**CITY OF NEPTUNE BEACH, FLORIDA
BIDDING, SPECIFICATIONS, AND CONTRACT DOCUMENTS
FOR
NEPTUNE BEACH SENIOR ACTIVITY CENTER
PORCH AND EXTERIOR FINISHES
CONB BID NO. 2023-01**

To: All Bidders
From: Jason Lupson, City of Neptune Beach Project Manager
Subject: Addendum #3
Date: 03/27/2023

ITB# 2023-01	Senior Activity Center Porch and Exterior Finishes
QUESTIONS	RESPONSES
1. Sheet A1 has an area on the North end of the building labeled as "Existing Pond", Civil Sheet 6 of 9 indicates that this is a "Dry-Swale" with an Earthen Weir Outlet on the West side of the building, which appears to be part of the bid work – please clarify.	Sheet A1 is provided for reference. Refer to civil and landscape plans for site work scope.

Footing Types
1/2" = 1'-0"

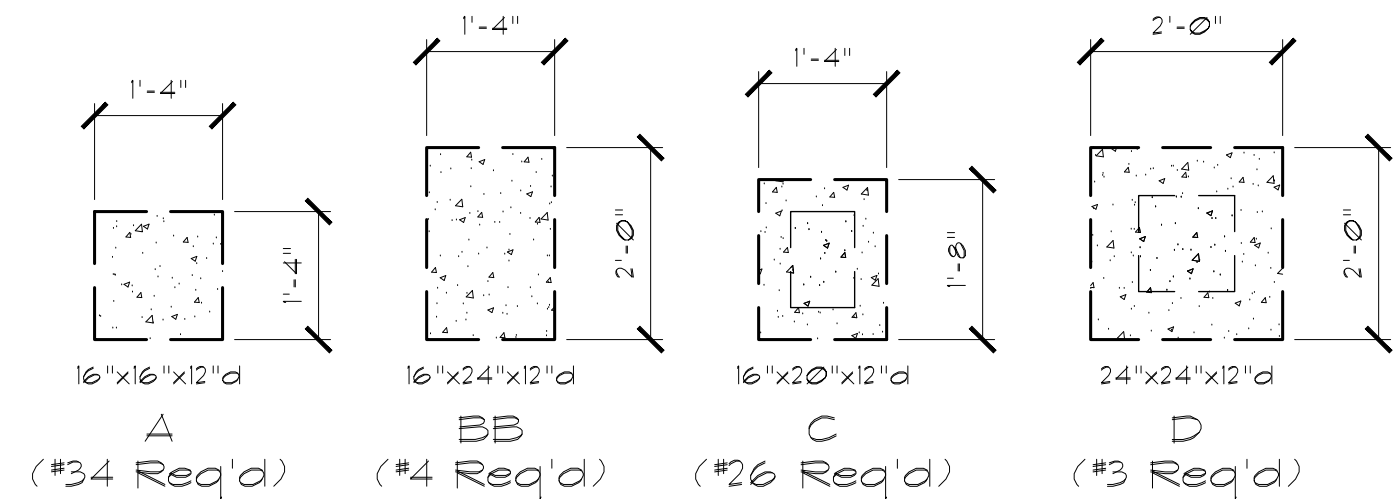
6. Can the footing types be labeled/identified on the foundation plan – Sheet A4	See attached.
7. Sheet A8 states fixtures "selected by owner" can you please clarify if that includes the owner purchasing the fixtures	The owner will purchase the fixtures. The contractor will install them.
